RESPONSE TO NRC LTR DTD 02/23/78... FORWARDING ADDL INFO OF REPT NEDM-20988,
"CAORSO RELIEF VALVE LOAD TESTS - TEXT PLANT" WHICH WAS SUBMITTED BY GE ON
BEHALF OF THE MARK II OWNERS GROUP.

SUBJECT: MARK II CONTAINMENT REQUEST FOR ADDITIONAL INFORMATION

RESPONSE TO NRC COMMENTS OF JULY 7, 1977 AND FEBRUARY 23, 1978
ON CAORSO TEST PLAN

FIG. 5-5E DC-ROCKNER VENT PRESSURE SENSORS

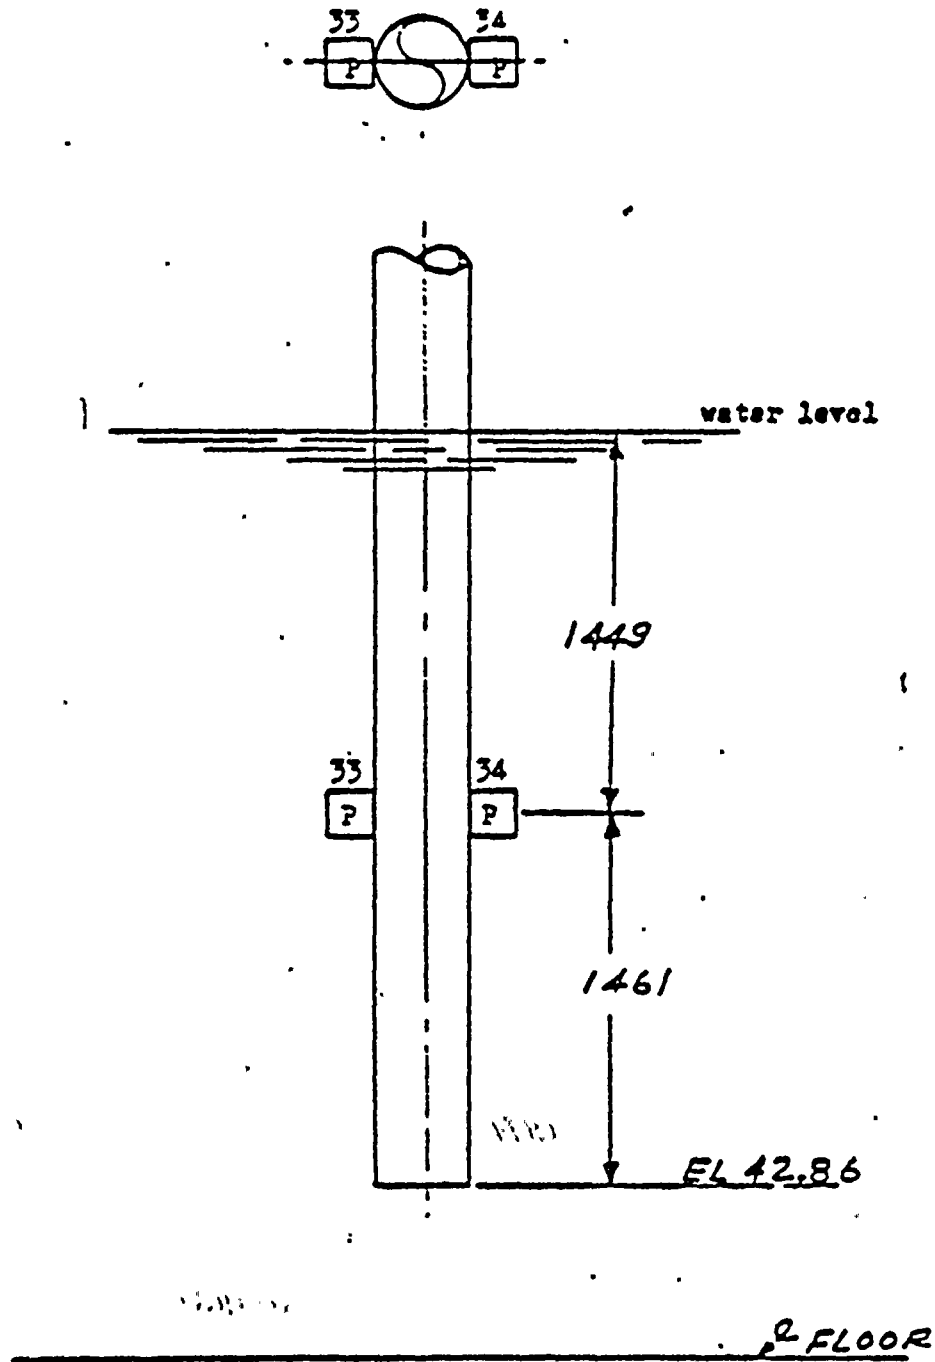
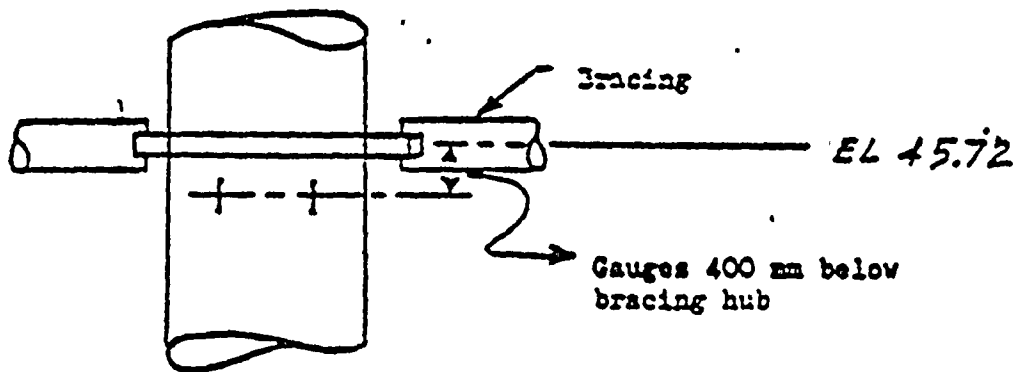
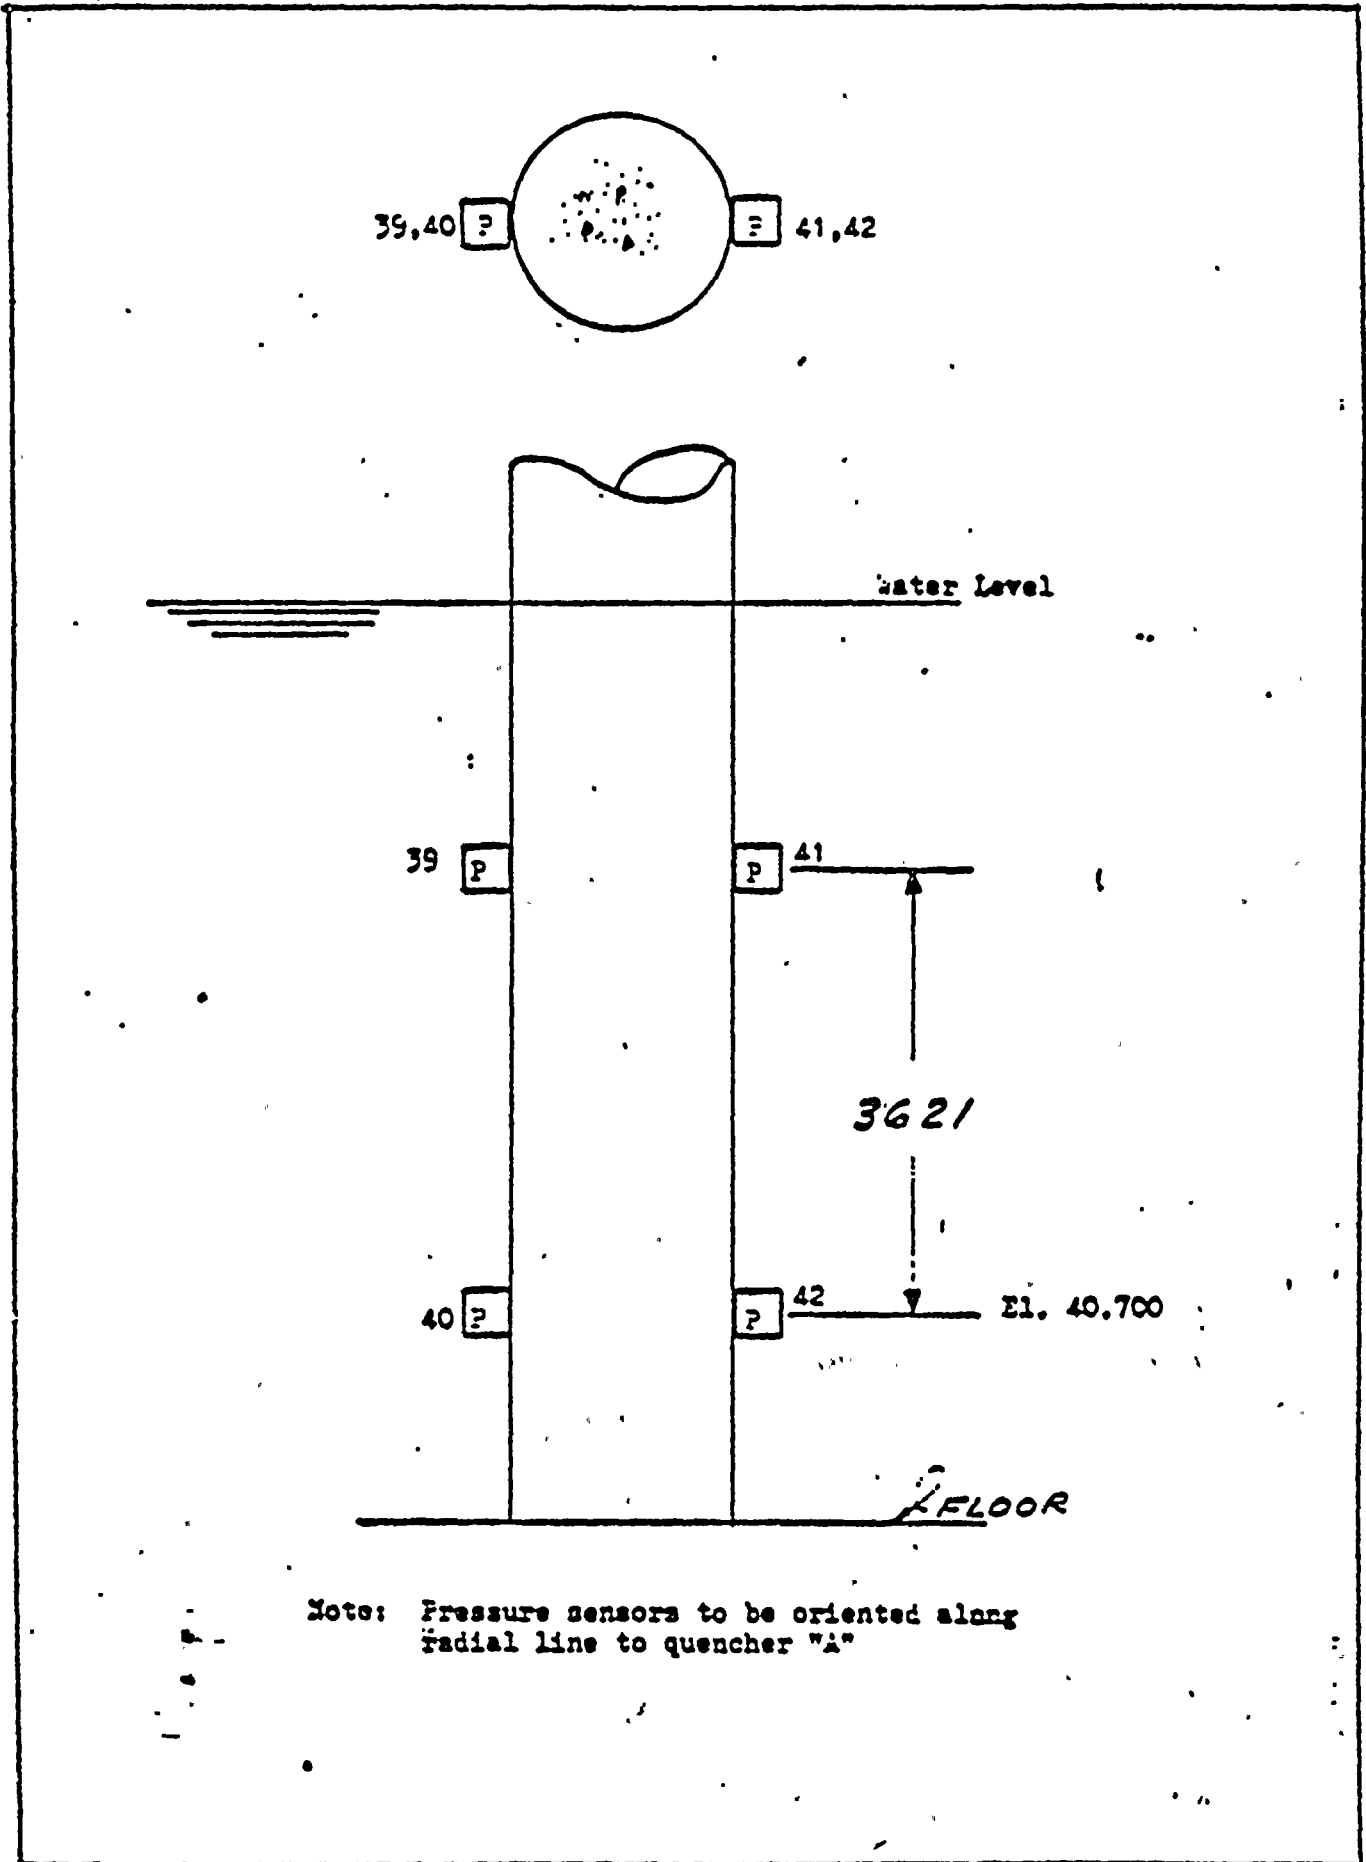
Submerged structure loads have been identified as a primary design load for the Mark II containment. We believe that the analytical program indicated in the Mark II Owners Group meeting which was held on February 16 and 17, 1977, is insufficient to support the design loads for submerged structure without experimental data. Therefore, we recommend that additional pressure sensors should be installed on support columns and downcomers to measure the drag load during SRV operation.

Instrumentation which has been installed at Caorso is expected to provide experimental data to support the analytical quencher models relative to submerged structure load caused by SRV actuations.

Measurements on two downcomers and a support column adjacent to Quencher A will provide the needed loads information. The instrumentation used, which is shown in attachments 6, 7 and 8 consists of the following:

1. Strain gauges on vents Nos. 1 and 9.
2. Pressure transducers on Support Column No. 7 and Vent No. 9.

GE believes the information obtained on pressure loadings, supplemented by the strain gauge data, will provide sufficient information to show that the analytical models predict reasonably conservative loads. The in-plant test data itself is not intended to provide a loading basis for submerged structure loads that can be directly or indirectly applied to define loads for other Mark II plants. The tests are planned as a confirmatory test to show the conservatism of the analytical models, which could then be used to define loads for other structures (not instrumented in Caorso) and for structures in other Mark II plants.
